CERTIFICATE OF APPROPRIATENESS – Minor Alteration

This letter provides you with certification that proposed work to your designated Fort Collins landmark property, the William & Violet Jackson/Robert Bailey Property at 1306 W. Mountain Ave. has been approved by the City's Historic Preservation Division (HPD) because the proposed work includes only minor modifications to plans already reviewed by the Historic Preservation Commission (see attachment), and meets the requirements of Chapter 14, [Article IV](#) of the Fort Collins Municipal Code.

BERKHAUSEN REMODEL/ADDITION
1306 WEST MOUNTAIN AVE
FORT COLLINS, COLO 80521
SWETT'S ADDITION

REMODEL and ADDITION
BASEMENT FLOOR PLAN

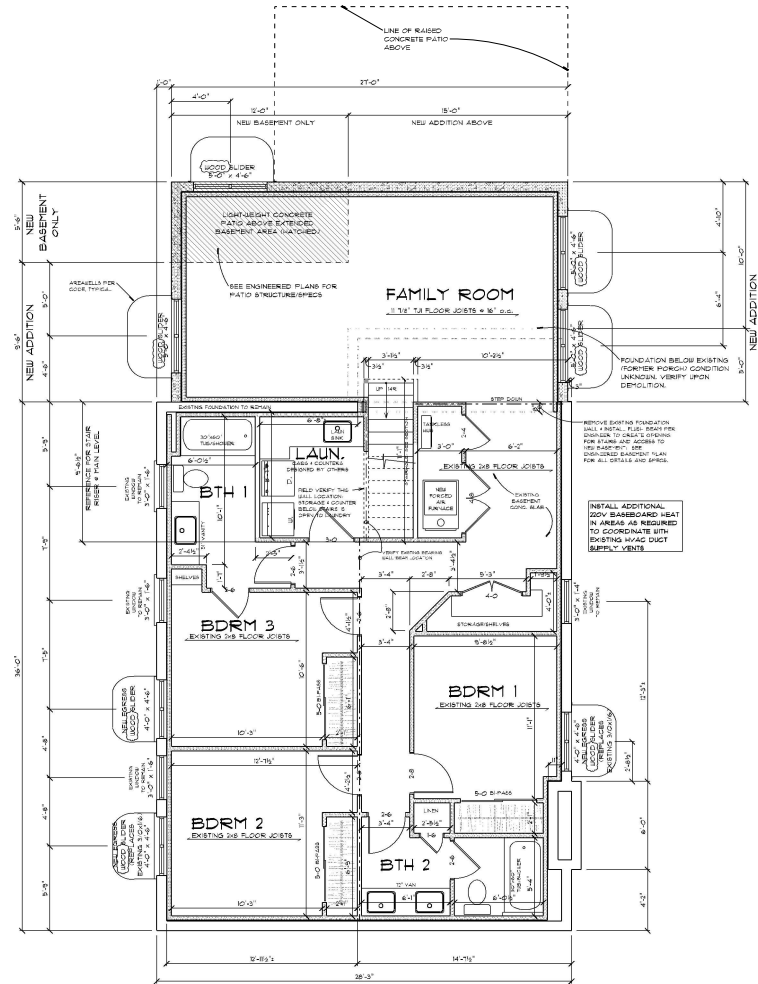
- Modifications to plans approved by HPC – On the existing house
 - West elevation basement window locations finalized – 3 existing to remain, 1 existing replaced with sliding wood egress, 1 new sliding wood egress

3. *Modification of windows on the west wall of the northwest bedroom of historic house with condition that the window treatment of the northwest bedroom in the historic building be modified to retain the existing window opening, delete one or both of the proposed two new window openings, and install an egress-compliant window in the existing historic opening (condition met by attached plans)*

REAR ELEVATION
NORTH
SCALE: 1/4" = 1'-0"

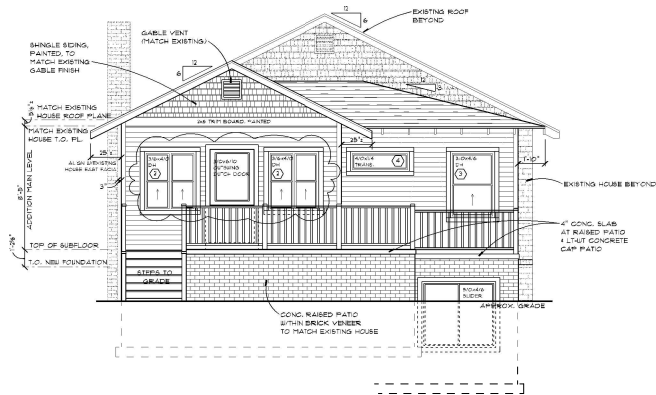
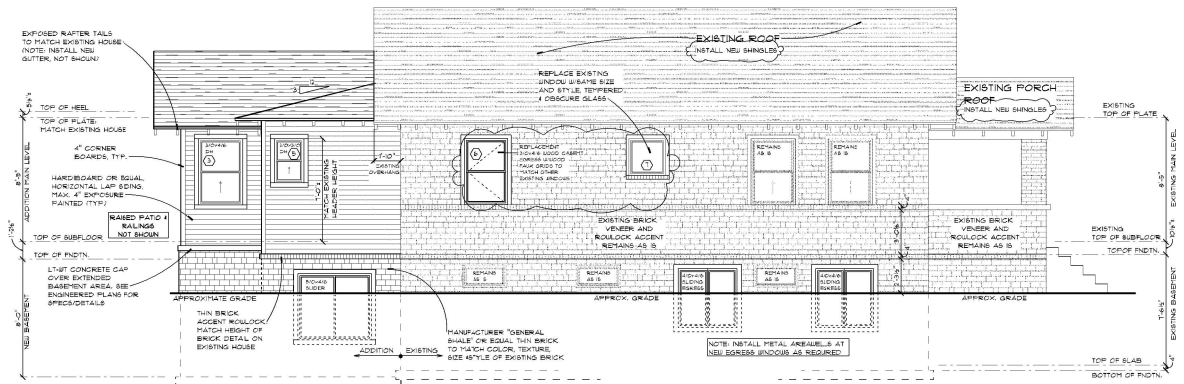
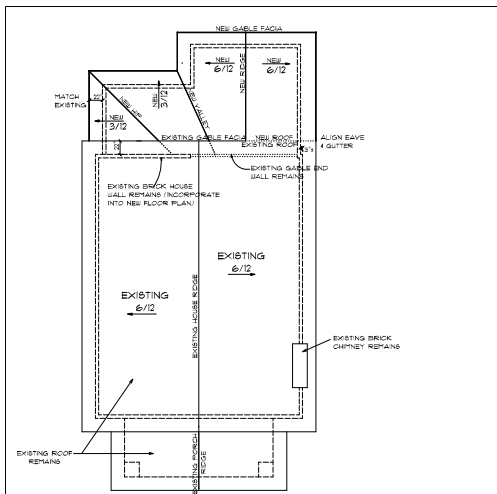
- Sliding wood basement windows: North elevation (1); West elevation (1); East elevation (2)
 - Double-hung wood window on east elevation – dimensions changed to 5' x 3'9" and paired

- Back door type changed to outswing Dutch door
 - Rear elevation detail added – Trim board dimensions, gable-end shingles to match existing, gable vent to match existing, specifics of rear patio

- Tempered/obscured glass window on west elevation – Added detail of awning type and exterior wood, interior fiberglass material

- Re-roofing historic house (asphalt shingles)
- Install new gutter
 - *Condition 1: New gutter should not obscure exposed rafter tails.*
- Modifications to plans approved by HPC – On the addition
